Certificate of Appropriateness

2156 N. Sherman Blvd., Sherman Boulevard Historic District

Reinstall solid wood sash windows on the second floor in the existing openings. Window sashes to match height and dimensions of original windows.

**2156 N SHERMAN BLVD
BED-BATH RENOVATION**

WINDOW REPLACEMENT AT WEST ELEVATION - 2ND FLOOR

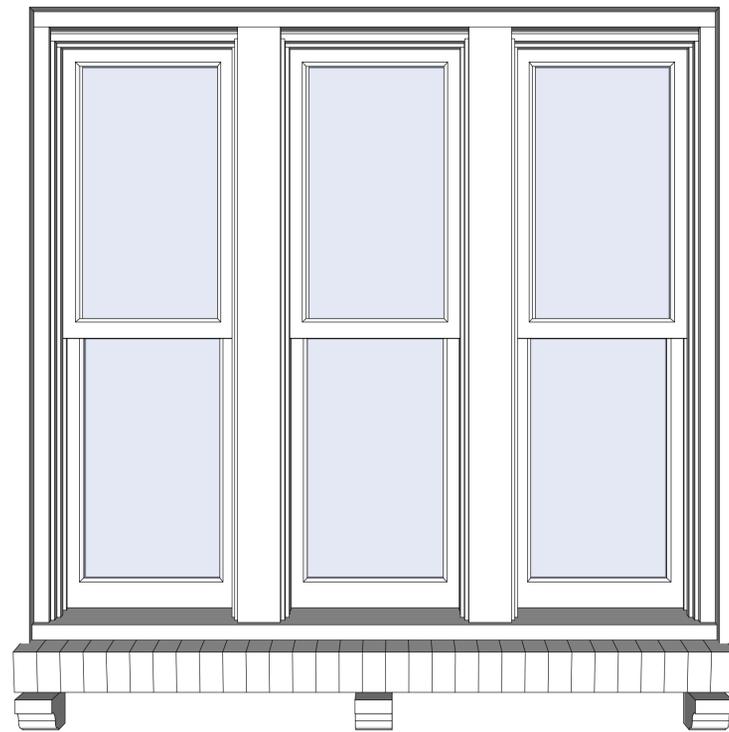
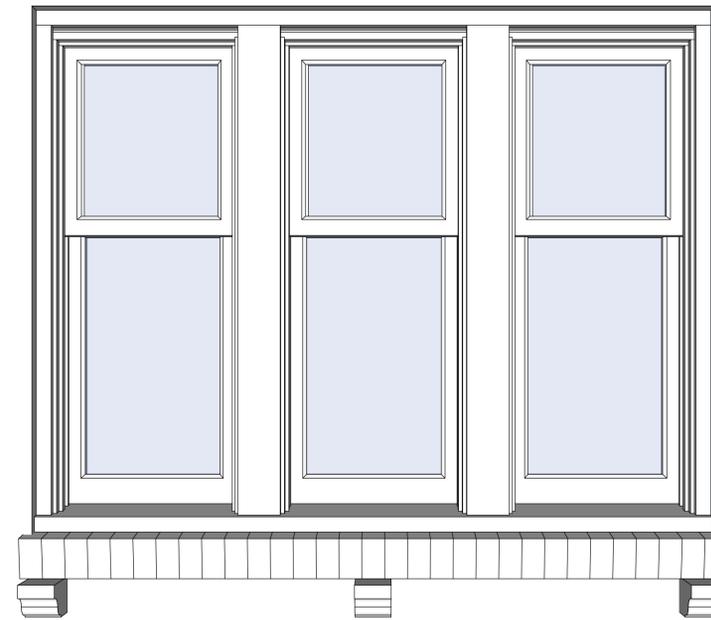
All finish wood must be smooth and free of knots and must be painted or treated with an opaque stain upon completion. Note: when new, bare wood is left exposed to the exterior elements for a period of only a week or two, the life the of the paint job subsequently applied to it will be decreased. The use of a decay-resistant wood for is required for porch areas. Using western white pine or Ponderosa pine is "at your own risk" because this wood has no natural decay resistance and can deteriorate in some exterior settings in just a few years.
